Advisory

## UV Bulb Replacement

ProCure

Top View of ProCure Chamber

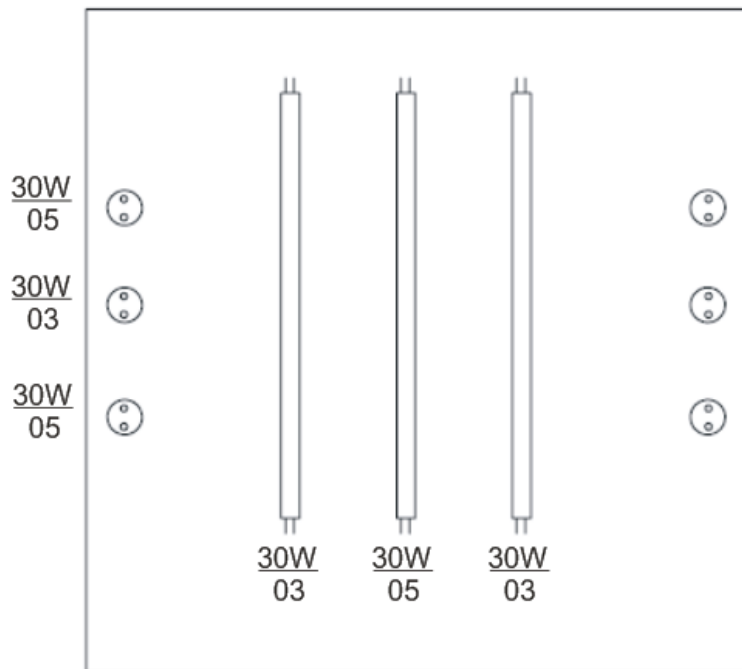
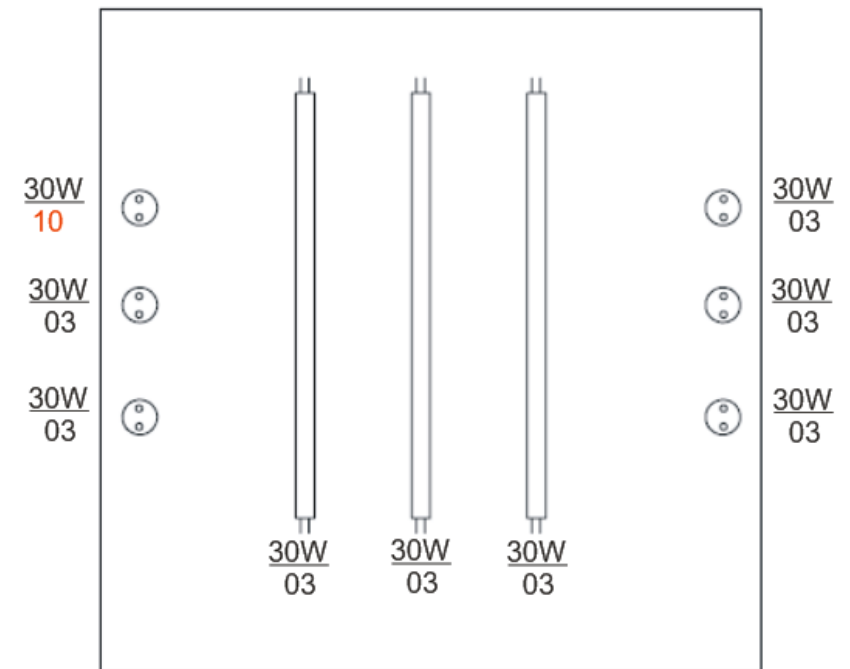
<b>ProCure Model</b>	P/N 23363-126-00 (Philips 30W/03)	P/N 23363-139-00 (Philips 30W/10)
ProCure 350 (P/N 23363-101-00)	Quantity 8	Quantity 1

Front View of ProCure Chamber

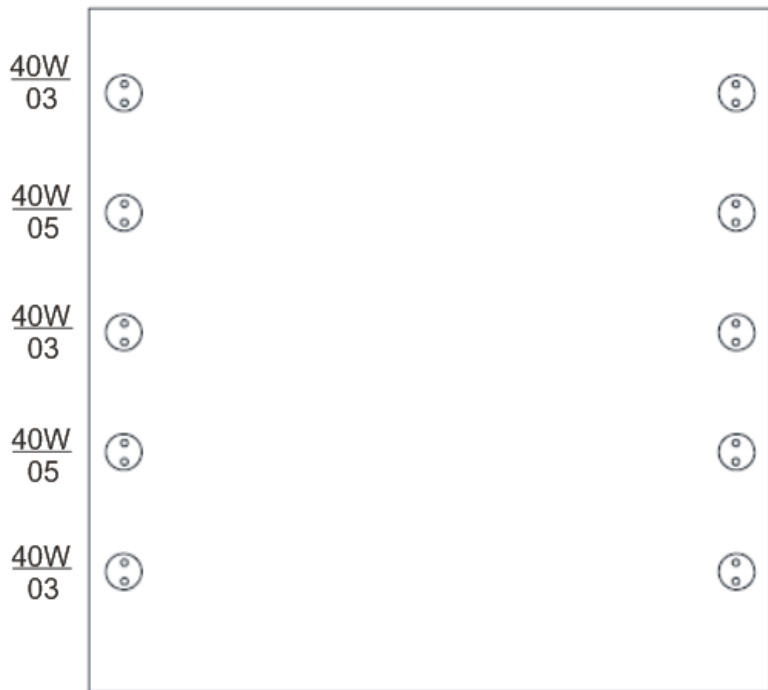
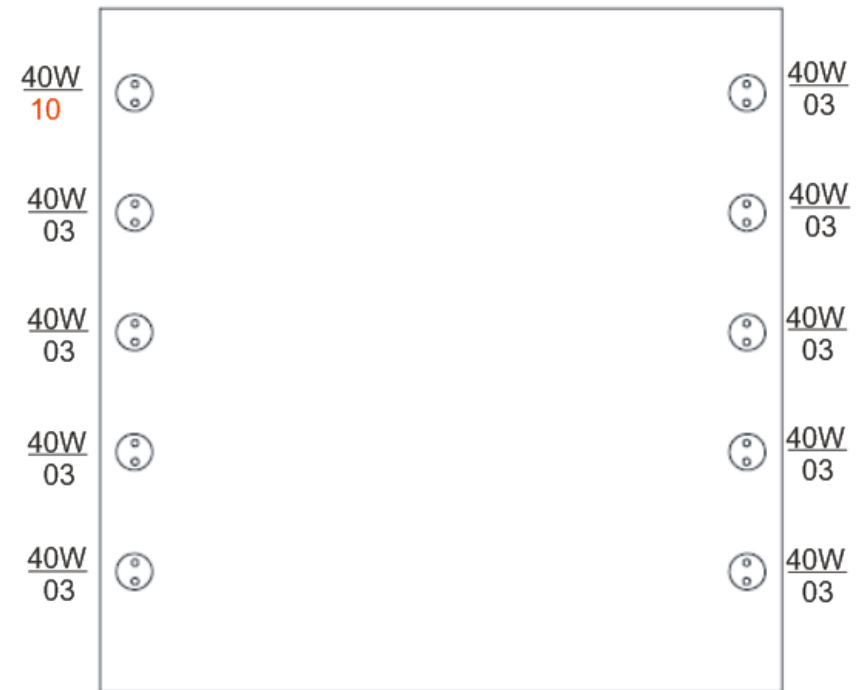
ProCure Model	P/N 16965-101-00 (Philips 40W/03)	P/N 23365-132-00 (Philips 40W/10)
PCA-250 (P/N 16990-9XX)	Quantity 9	Quantity 1
PCA-350 (P/N 20478-901)	Quantity 9	Quantity 1
PCA-350/3500 Assy, CE (P/N 21556-902)	Quantity 9	Quantity 1

Top View of ProCure Chamber

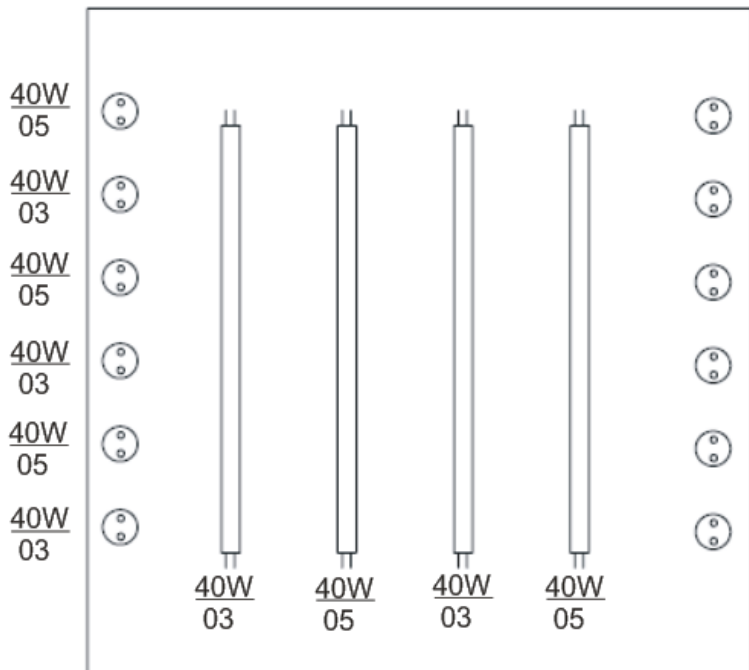
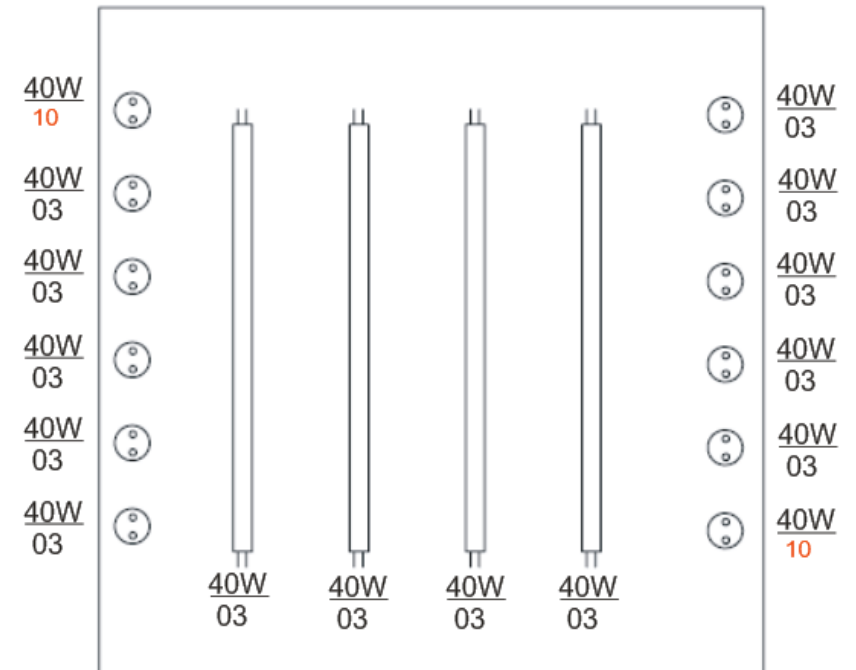
ProCure Model	P/N 16965-101-00 (Philips 40W/03)	P/N 23365-132-00 (Philips 40W/10)
PCA 500 System (20795-901-00)	Quantity 14	Quantity 2
PCA-500/5000/7000, CE ( 21431-903)	Quantity 14	Quantity 2

Top View of ProCure Chamber

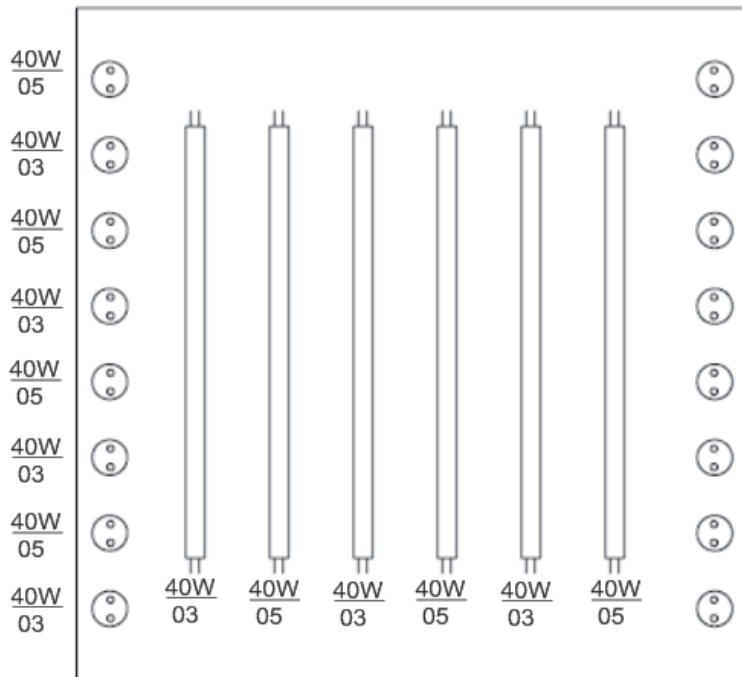
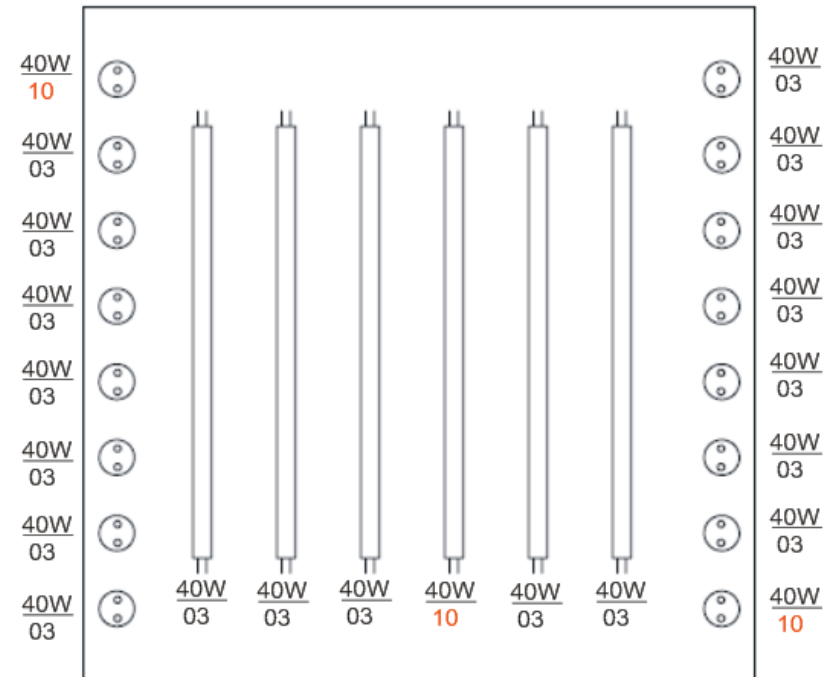
<b>ProCure Model</b>	P/N 16965-101-00 (Philips 40W/03)	P/N 23365-132-00 (Philips 40W/10)
ProCure 750 (23365-101-00)	Quantity 19	Quantity 3
